Site Plan

GRADING & DRAINAGE PLAN
Office & Warehouse Facility for the O'Dell Corporation
ALEXANDER BLVD. NE, ALBUQUERQUE, NEW MEXICO

GRADING & DRAINAGE PLAN
 Office & Warehouse Facility for the O'Dell Corporation
 ALEXANDER BLVD. NE, ALBUQUERQUE, NEW MEXICO

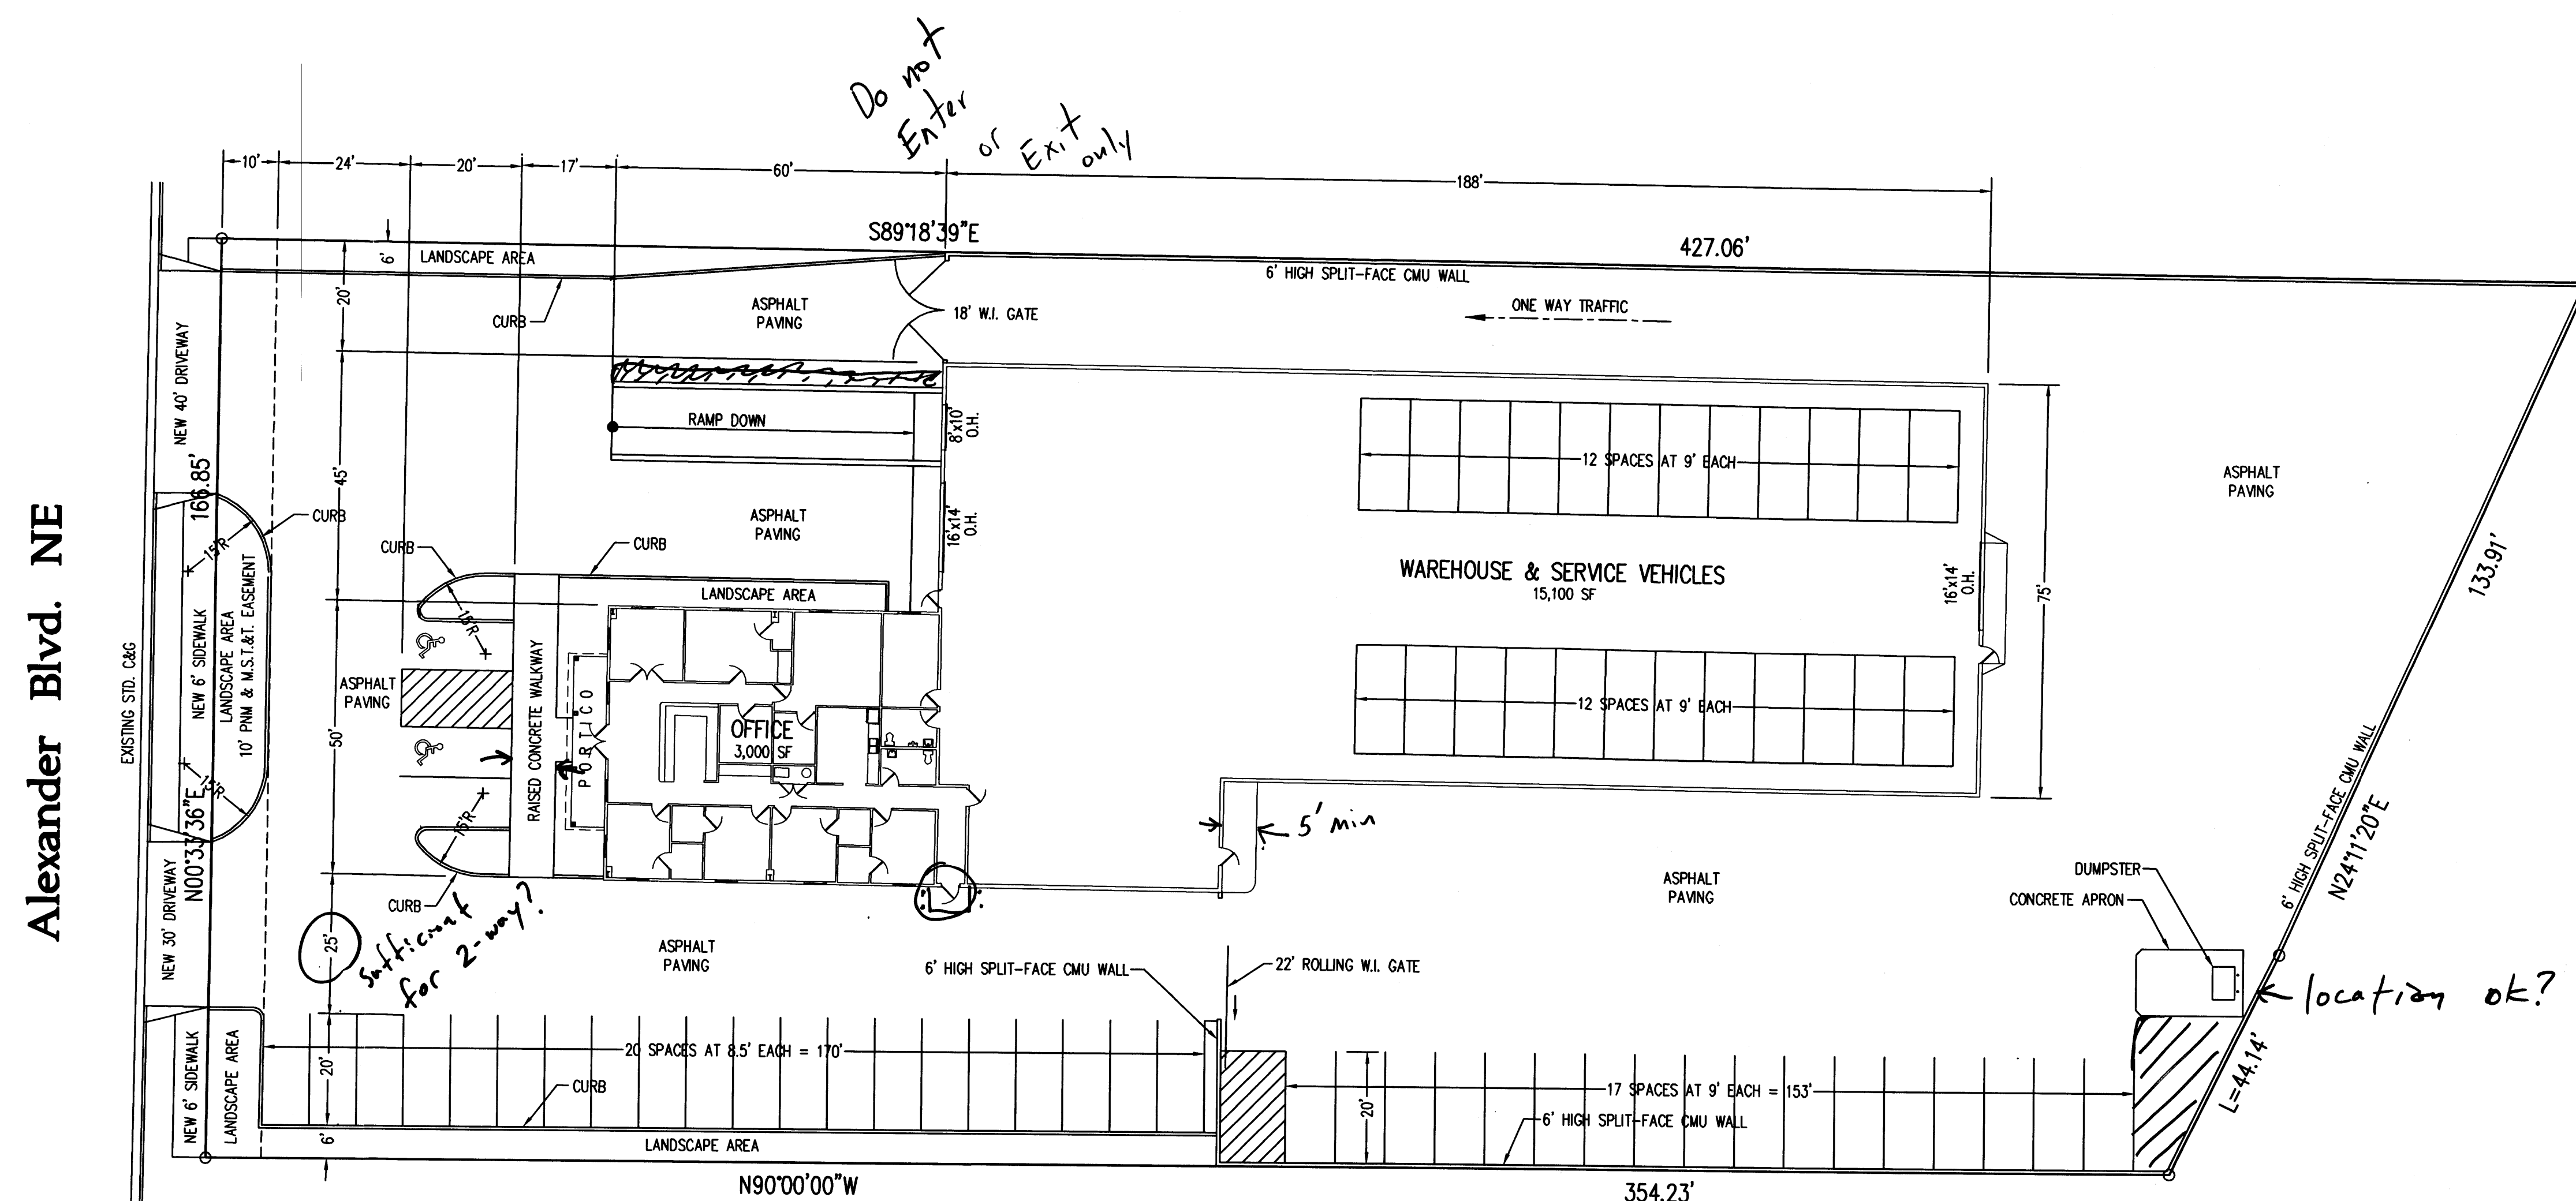
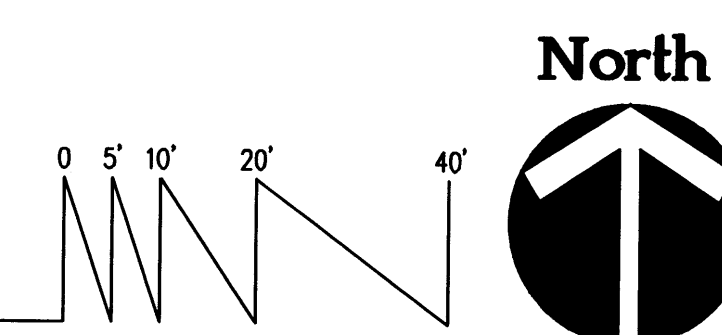
Vicinity map
size?
parking space req'd?
Signature for stamp
legend

- R/W?
- encasements?
- slopes
- What kind of service vehicles?
- how high is curb?

DETAIL "I"
NO SCALE

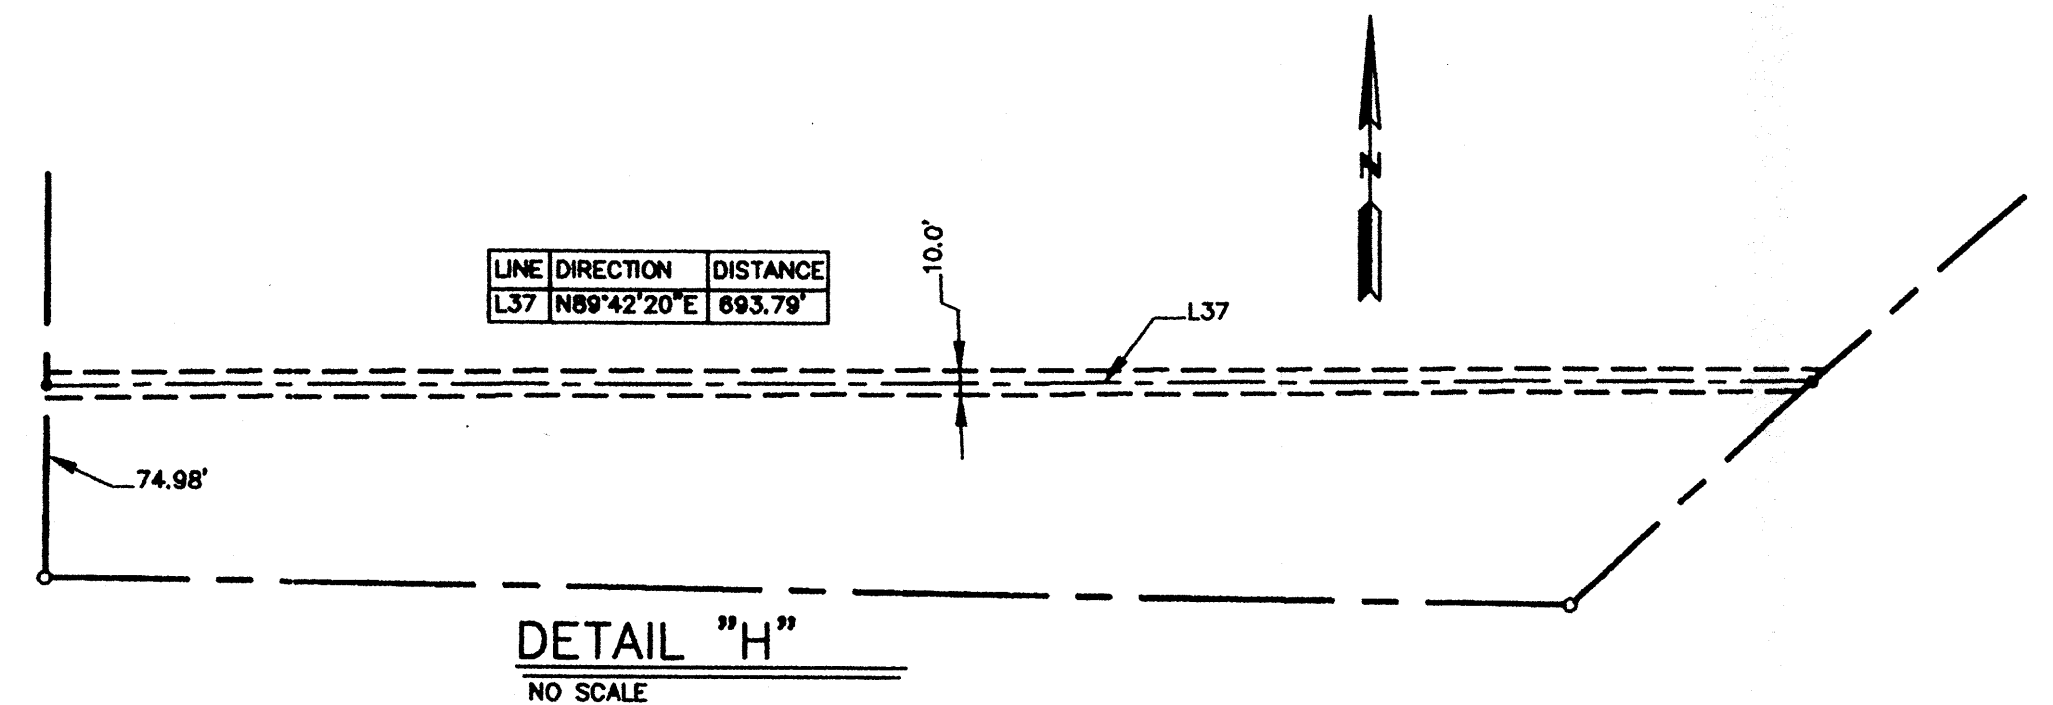
* Need
permission
for
draining
into
channel.
overhead
@ capacity.

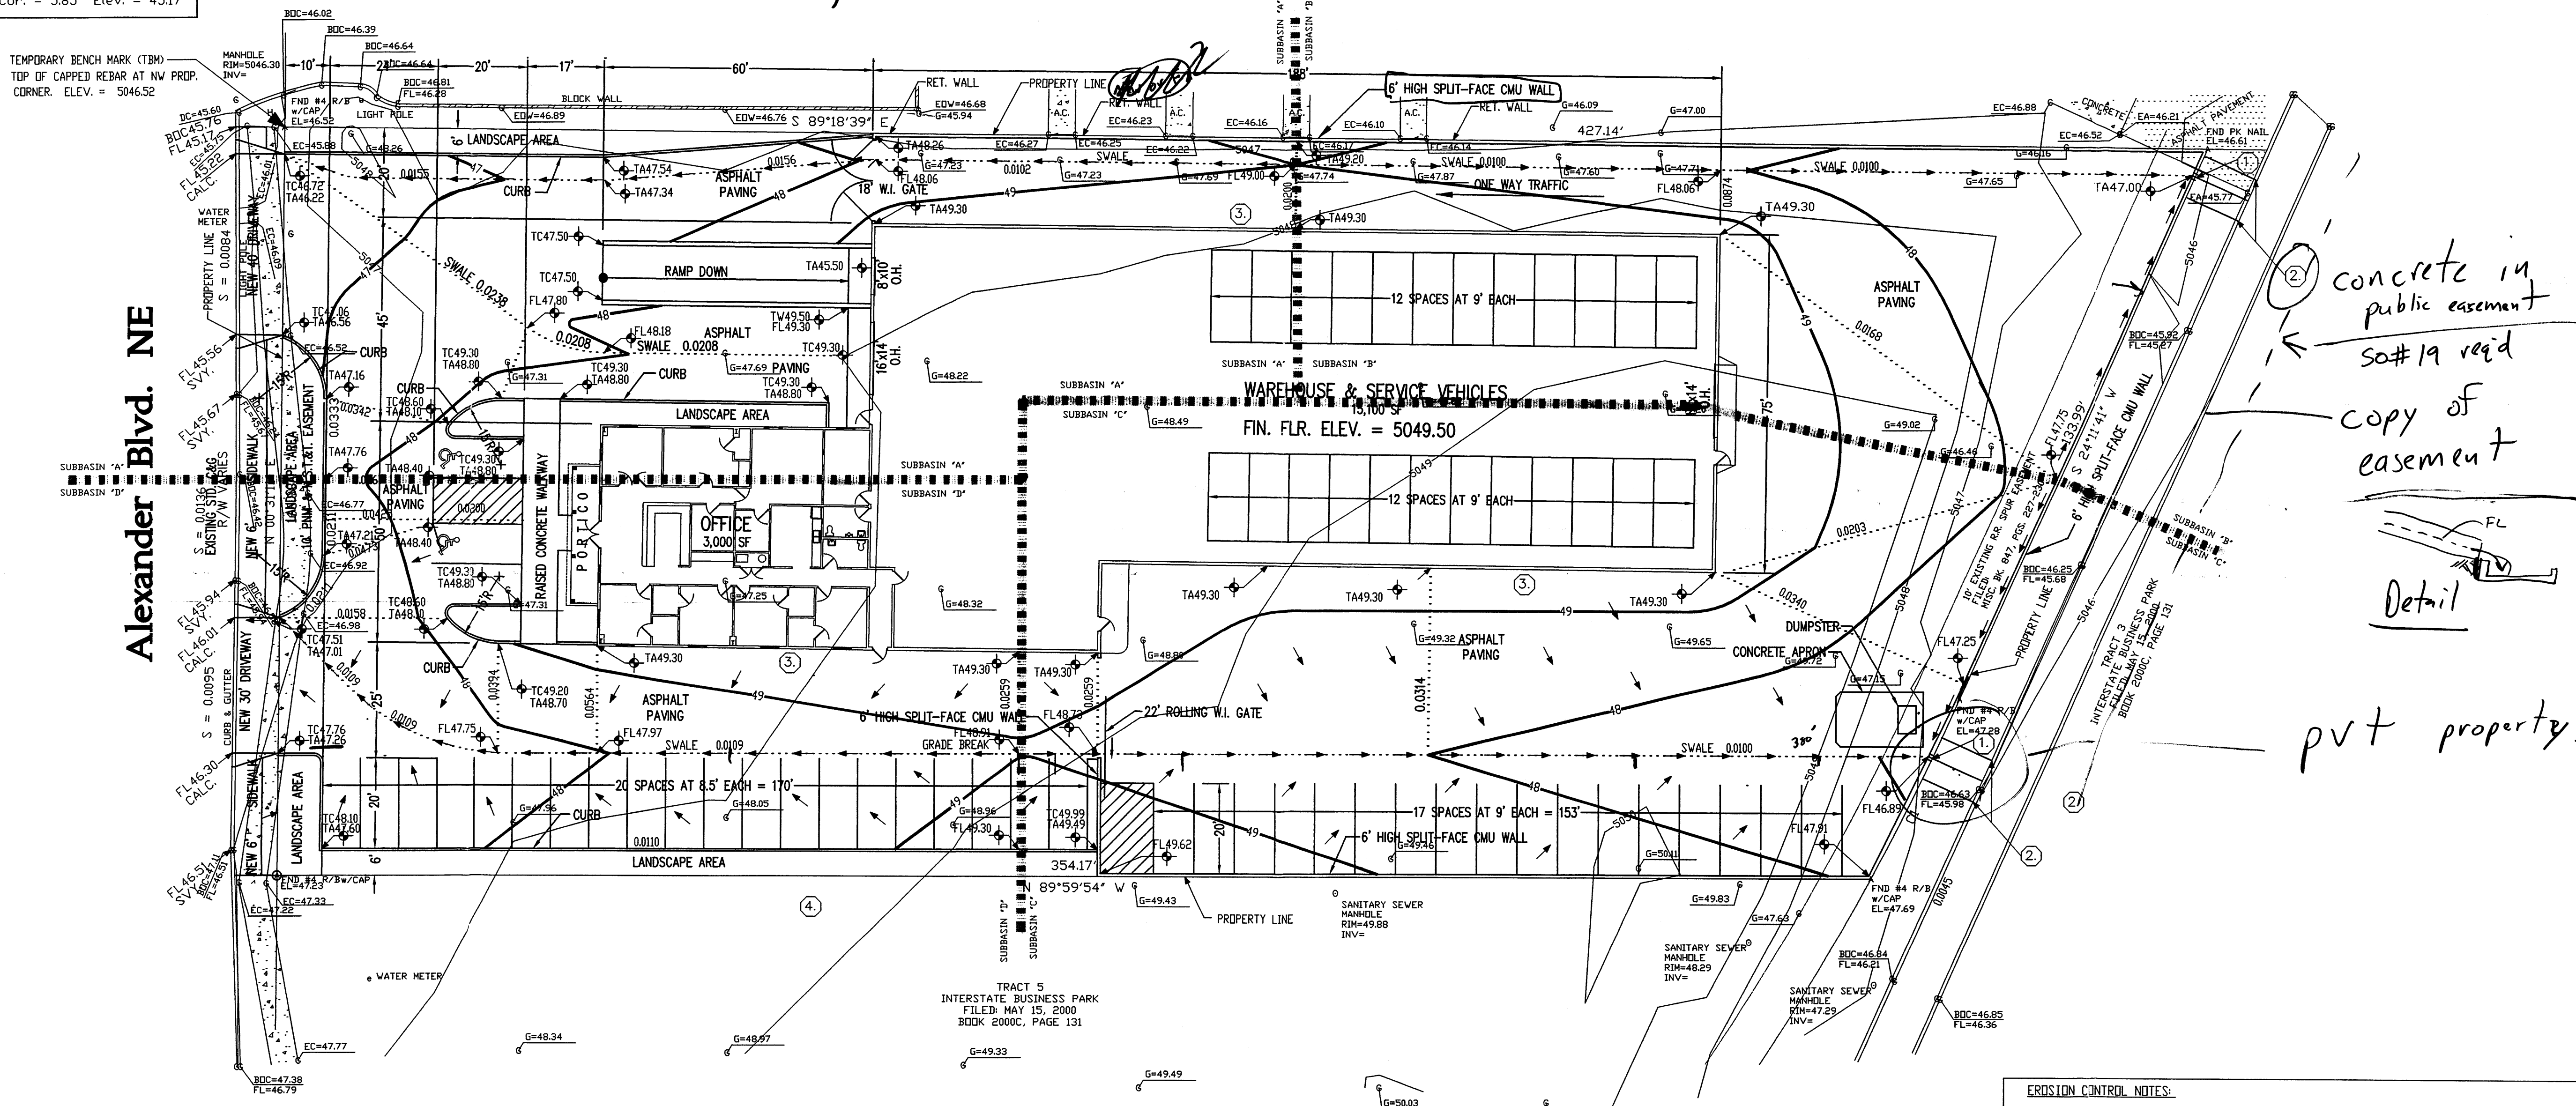
② concrete in public easement
 so#19 req'd
 copy of easement
 Detail
 pv + property?
